<b>R.F.I.</b> (REQUEST FOR INFORMATION)			
Project #:	600-12-163	RFI #:	20
Project Name:	Bldg. 2, Correct Deficiencies	Date Requested:	4/26/13
Solicitation No.:	VA262-13-B-0184	Reference:	Metal Lockers

Project #:	600-12-163	RFI #:	24
Project Name:	Bldg. 2, Correct Deficiencies	Date Requested:	April 29, 2013
Solicitation No.:	VA262-13-B-0184	Reference:	
Drawing:	AE100	Specification Section:

<b>Project #:</b>	600-12-163	<b>RFI #:</b>	<i>H26</i>
<b>Project Name:</b>	Bldg. 2, Correct Deficiencies	<b>Date Requested:</b>	
<b>Solicitation No.:</b>	VA262-13-B-0184	<b>Reference:</b>	Duct Cleaning
<b>Drawing:</b>	MH100	<b>Specification Section:</b>	None

HTG, VENT & AIR CONDITIONING  
BASEMENT FLOOR PLAN-SPLIT

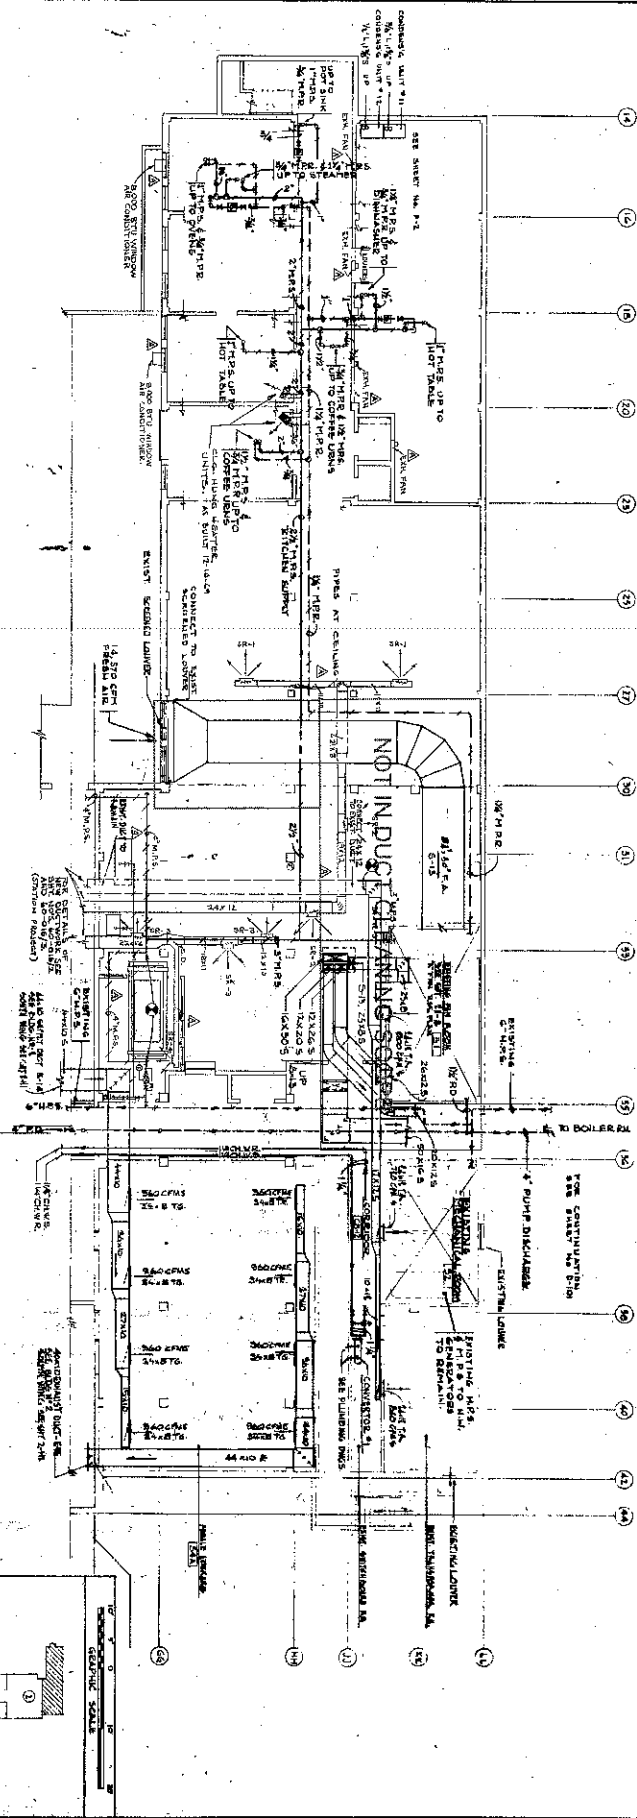
Please see drawing MH100 Sheet Note 5 that states "After modification of ductwork is complete. Entire Duct System shall be cleaned. The entire duct system is not shown on the mechanical drawings so it is very difficult to put a price together. Please advise or provide as-built mechanical drawings.

During design it was indicated that Duct Cleaning cost was determined by Building Floor Area. However, to provide better description of duct system to be cleaned attached to this RFI response are scans of As-Built drawings provided to design team by VALBHS. Also, indicated on these drawings are areas that are not to have duct cleaning due to work performed or being performed by other projects.  
Kevin Gustin, d'Autremont-Helms, 05-03-2013
